**From:** Gillean Hoehnke [REDACTED]  
**Sent:** 18 May 2021 11:27  
**To:** Planning & Regulatory Services  
**Subject:** RE: [OFFICIAL] FW: Application Ref: 21/00595/PPP  
**Attachments:** Access road - Junction with A708.pdf; Deuchar Mill Properties. - Extract from Title Deeds.pdf

**Applicant's response to comments by members of the public in respect of 21/00595/PPP**

I write regarding Planning Application 21/00595/PPP  
Submitted by Buccleuch Estates Ltd.  
Site Address: Land East of Deuchar Mill House.

## Deuchar Mill, Yarrow - Access road, junction with A708

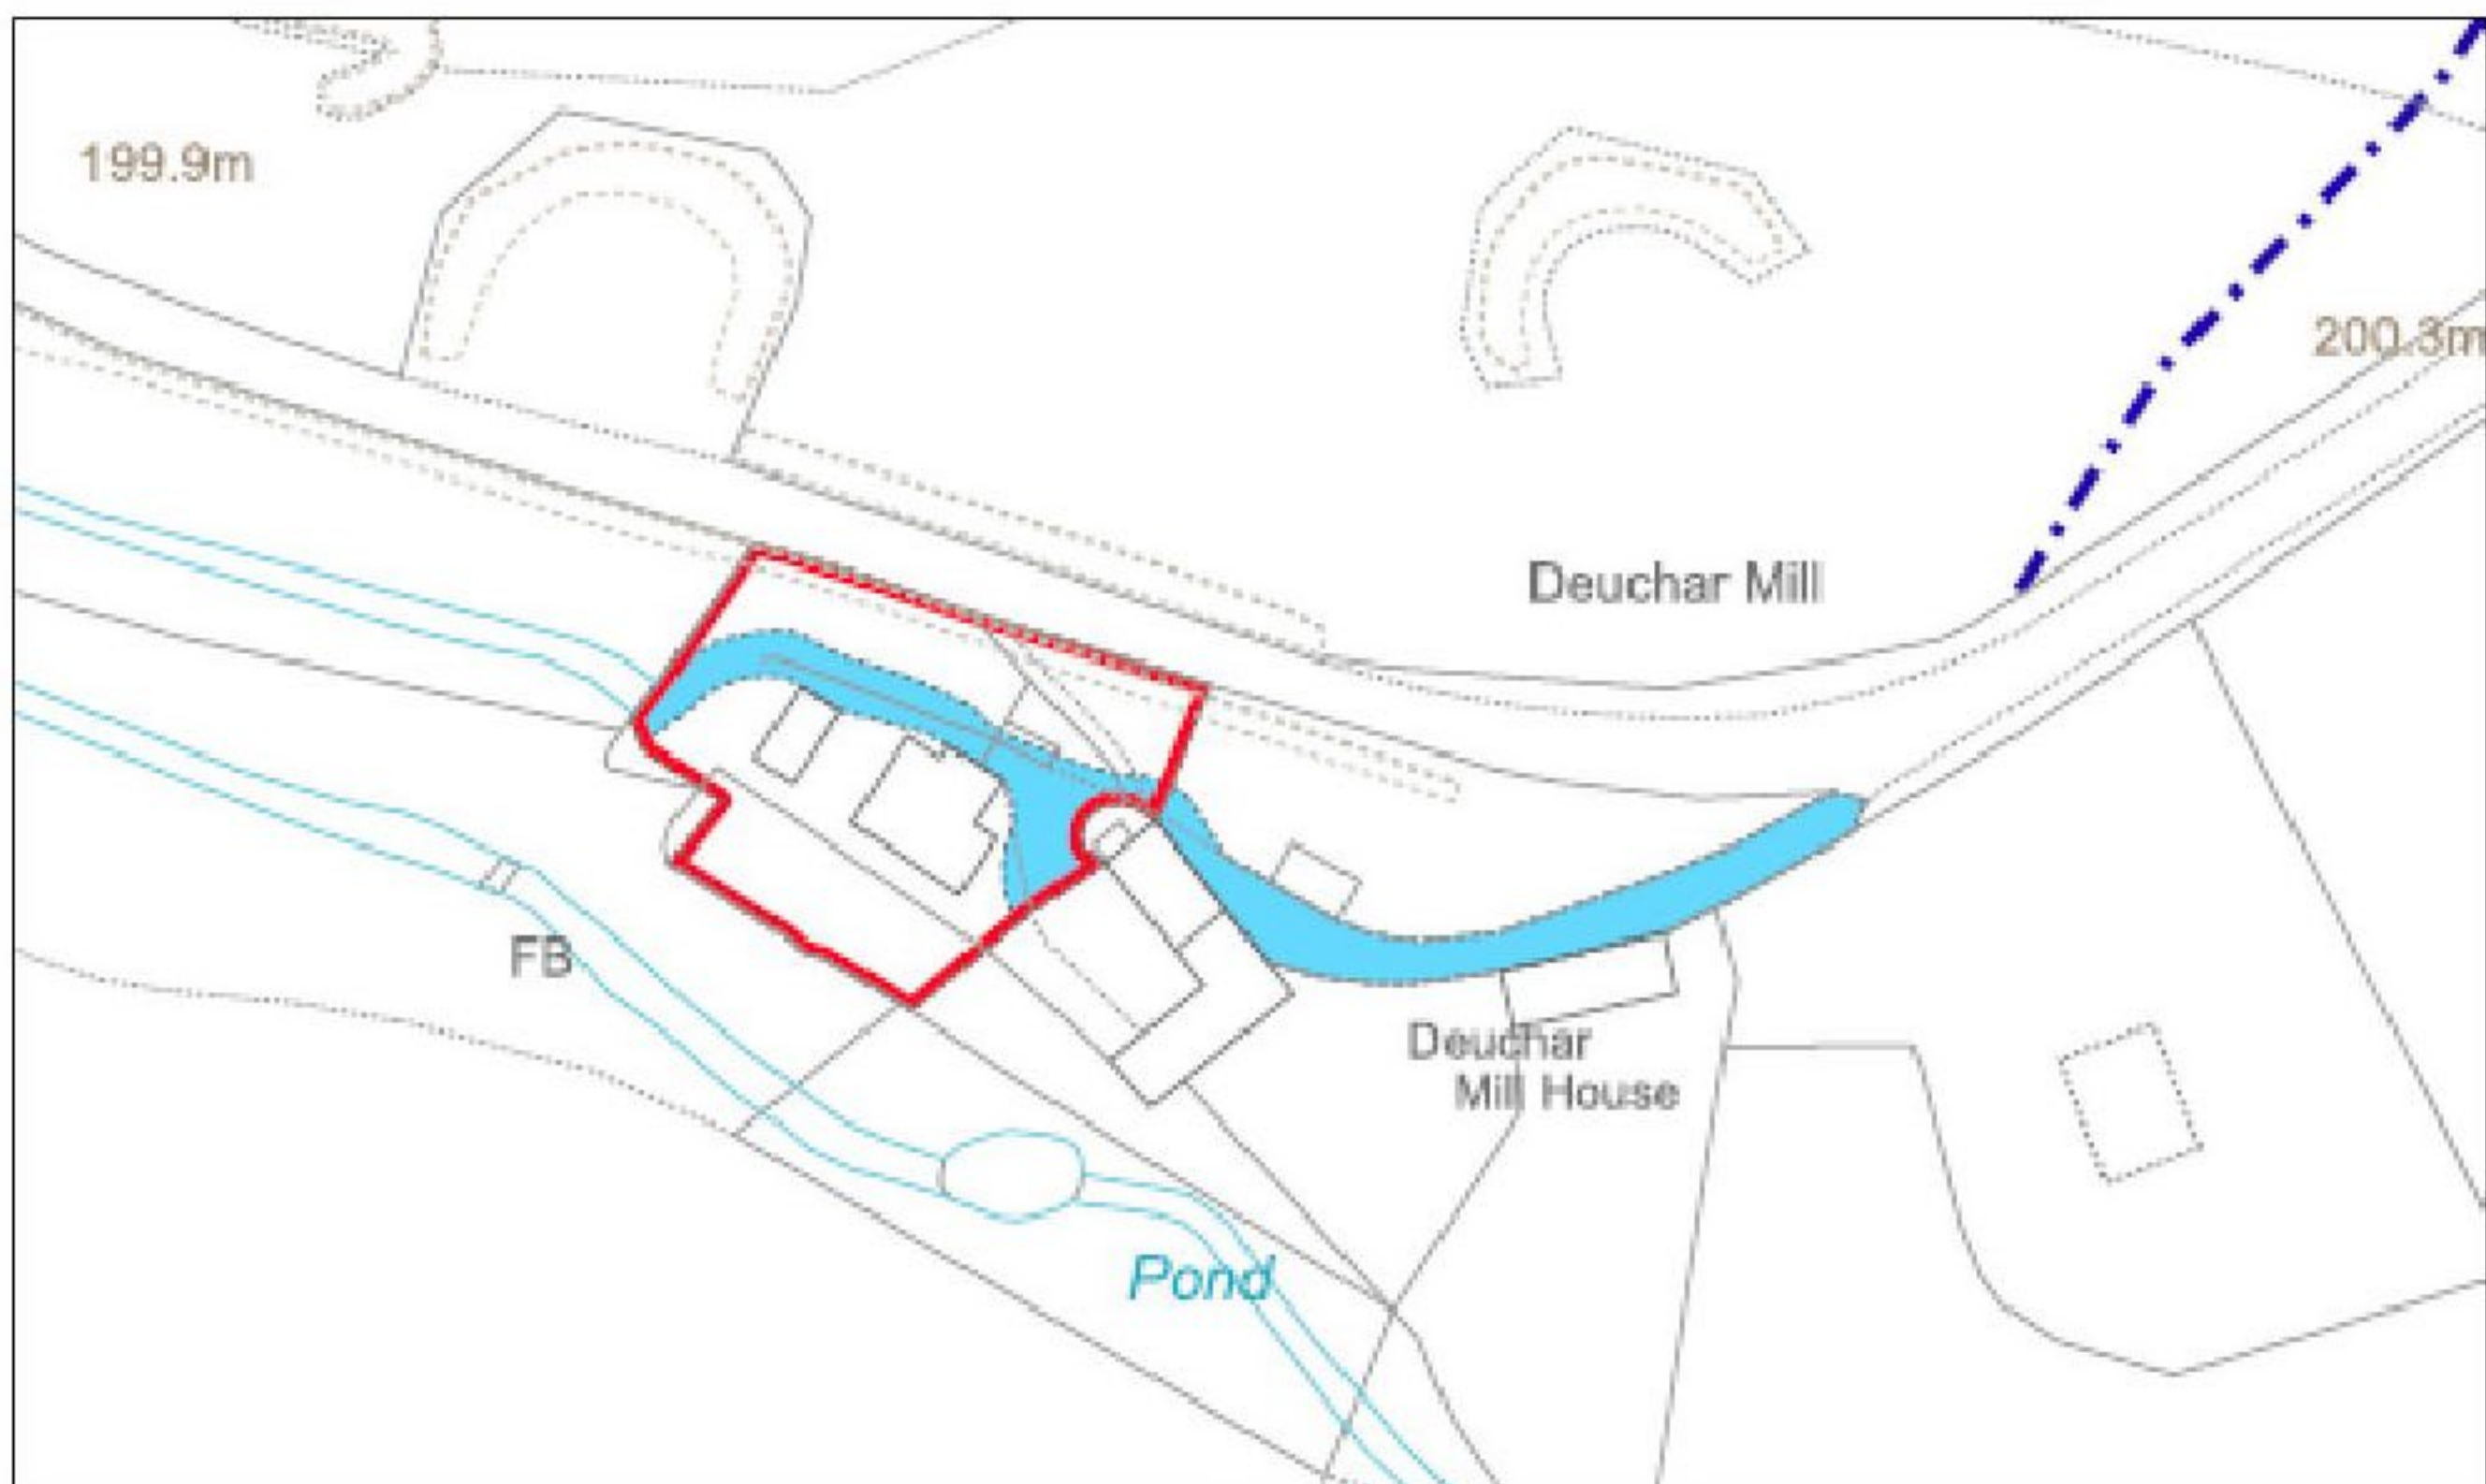
Further to your letter dated 29th April 2021 regarding a proposed dwelling house adjacent to my property Deuchar Mill Cottage, the site plans submitted by Buccleuch Estates lack clarity as to how the site will be accessed.

Following a discussion with a representative of Buccleuch Estates on site it appears that the applicant wants to make use of our access road at the point where it joins the A708, to gain access to their proposed development ( see attached photographs). Our Title Deeds, however, restricts the use of a any part of our access road, so far as the estate is concerned, to farm use and estate business. Consequently, the estate has no right to make use of our road for any other purpose, including access to a proposed development.

I am requesting detailed information from the estate to determine if they intend to breach the provisions of the said Title Deeds, which clearly show how our access road joins the A708, as shown on the Land Registry website, <https://scotlis.ros.gov.uk/property-summary/SEL6920>.

Will you also request a detailed layout plan of the access and let me have your observations.

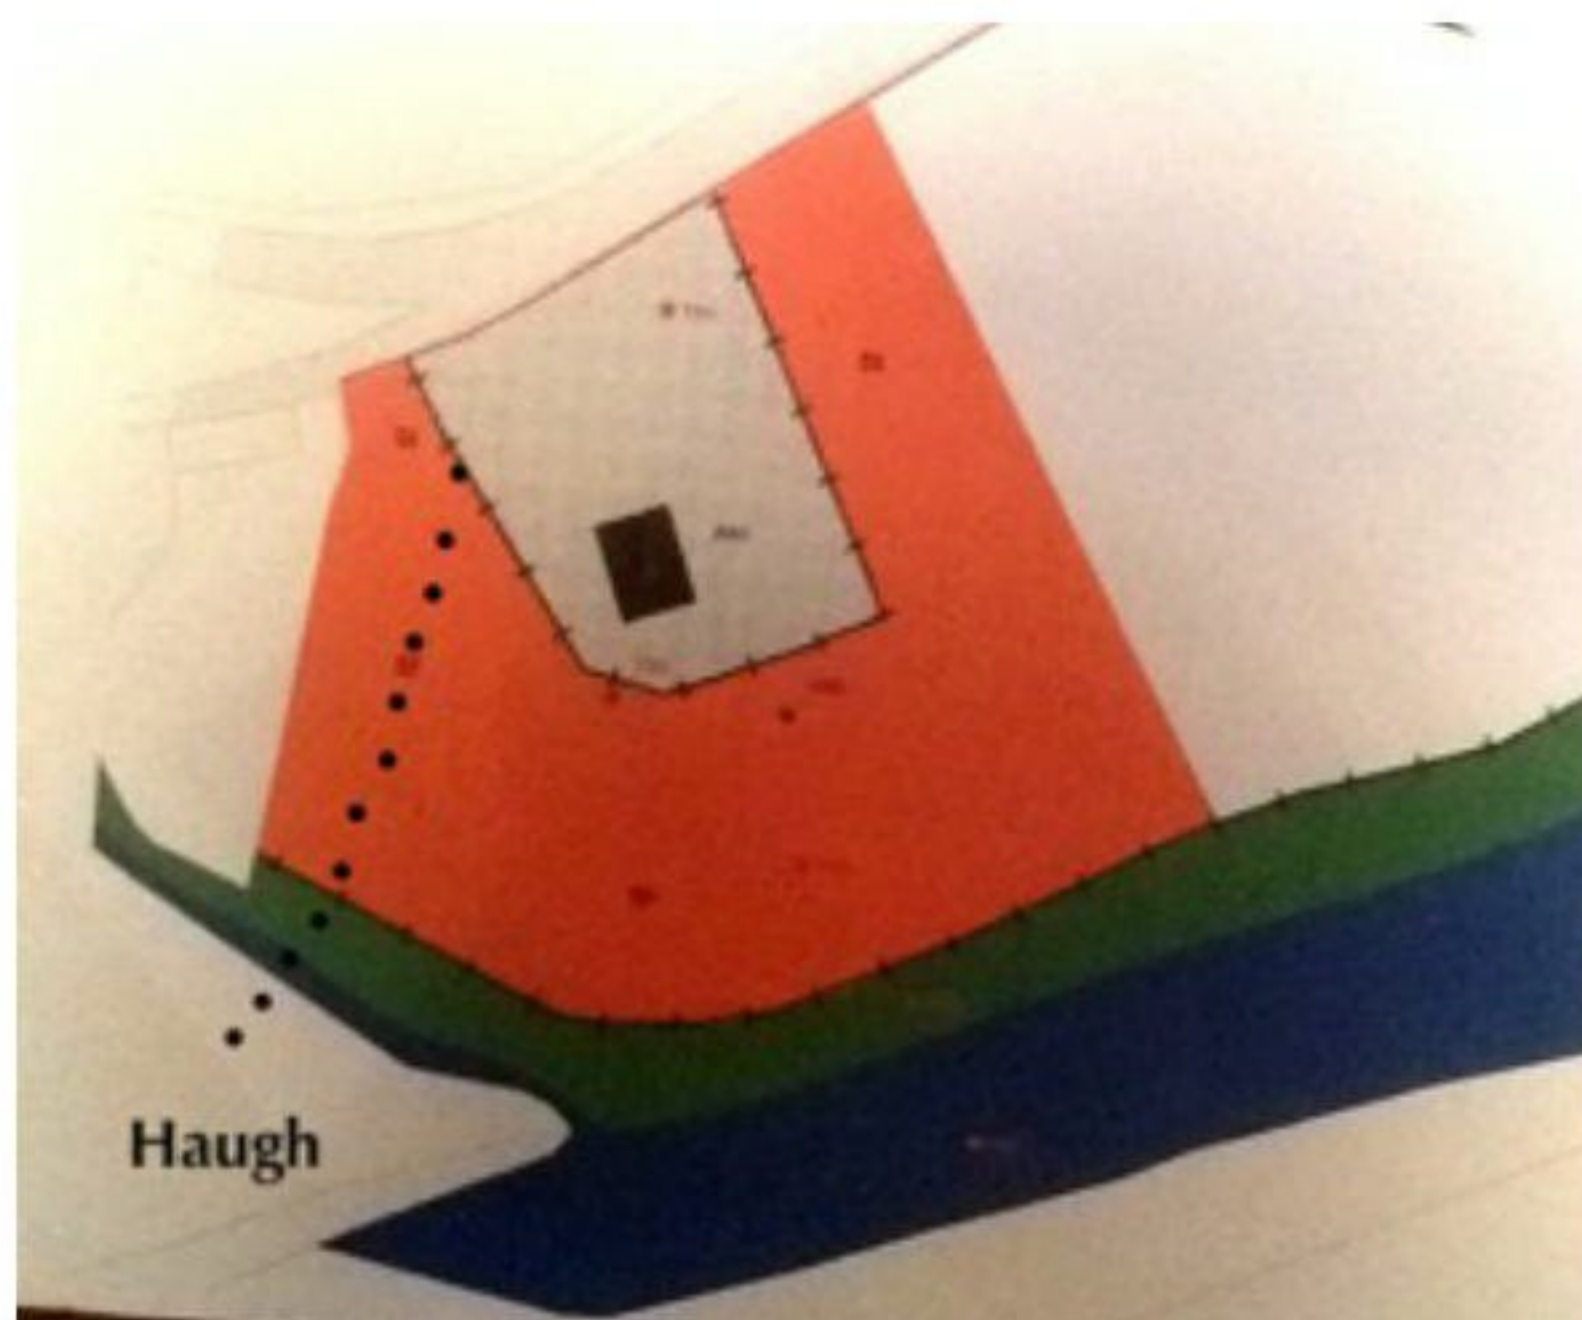
1. I confirm that the existing access to the stackyard, is tarmac: that is a layer of crushed stone and tar. However the existing access track to the three properties itself is not: this is surfaced with a road metal of gravel and crushed stone.
